SERVICE BULLETIN: JSB 033-1

Subject: Piston Circlips

Affected Models: Jabiru 2200 and 3300 Engines

SAFETY DIRECTIVE: JSD 033-1

Figure 1 – Type A (Left) & Type B (Right) Circlips¹

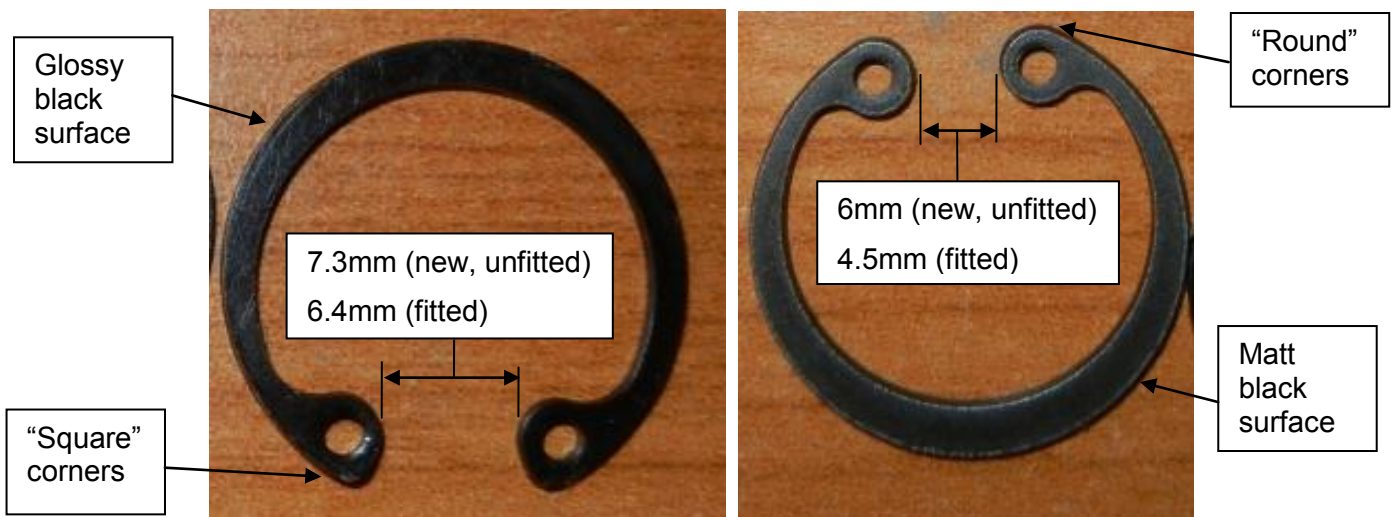
- Subsequent testing has shown that these clips are unusually sensitive to installation technique compared to clips manufactured to DIN 472. In particular, the JIS clips have a larger gap between the clip “eyes” giving greater potential for installers to over-compress and damage the clips on installation. In Figure 1 the “Type A” clip meets JIS B 2804 while the “Type B” clip meets DIN 472.

- In some cases “Type A” clips have dislodged in service leading to heavy engine damage.
- This bulletin details inspection and repair requirements to correct this condition.

- Type B Circlip is Jabiru P/No. PH0545N.

- Disassemble the engine and replace Type A clips with new Type B parts.
- Thoroughly inspect the pistons for damage or wear to the circlip groove. If wear or damage is noted contact Jabiru Aircraft for additional guidance.
- **OR** Return the engine to Jabiru Aircraft or our local authorized representative for correction.

Figure 2 – Clip Installation Details

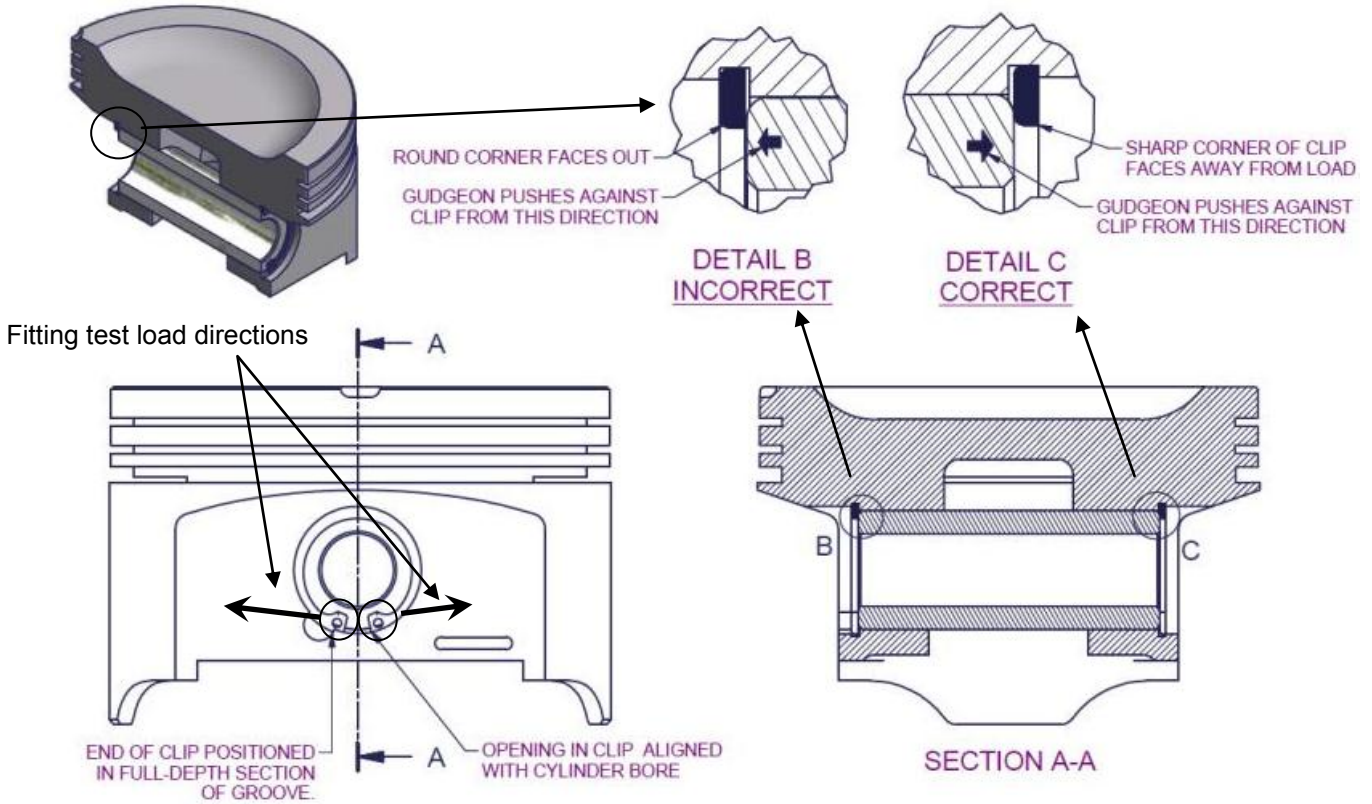
- Clips must be oriented correctly on installation: See Figure 2: the clips must be fitted with the sharp-edged corner facing outwards.
- When installing clips compress them by the minimum amount required for fitting. DO NOT compress them until the eyes of the clip touch.

- Ensure that the opening in the clip is oriented as shown in Figure 2: it must face along the axis of the barrel.
- Ensure that the ends of the clip are both positioned within full-depth sections of the groove as shown in Figure 2.

- After fitting use a small screwdriver or pick to apply pressure to the clip as shown in Figure 2: the clip should not rotate. If the clip moves, discard it and fit a replacement.

Figure 3 – Worn Circlip Grooves.

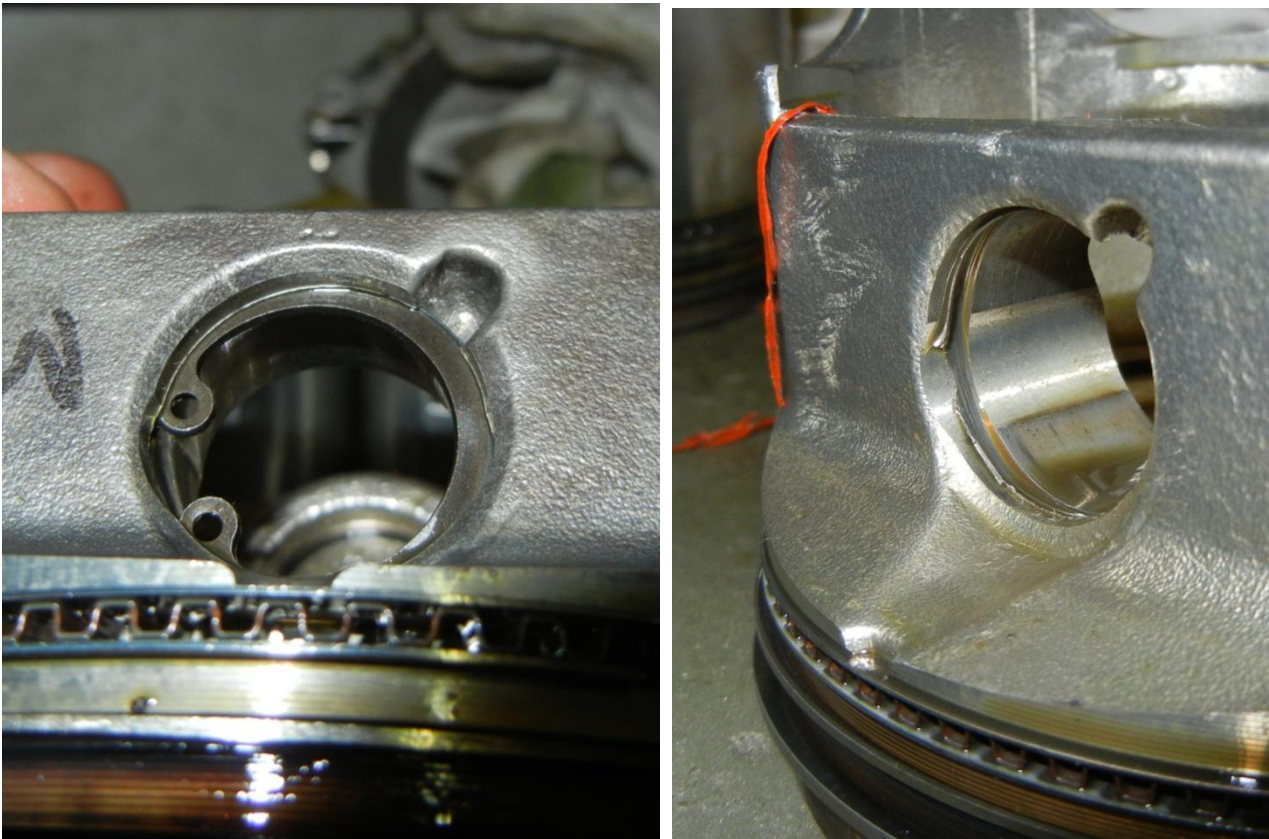
- Thoroughly inspect pistons for wear or damage before installing new clips. Figure 3 shows two pistons with worn grooves. Worn pistons must not be re-used.
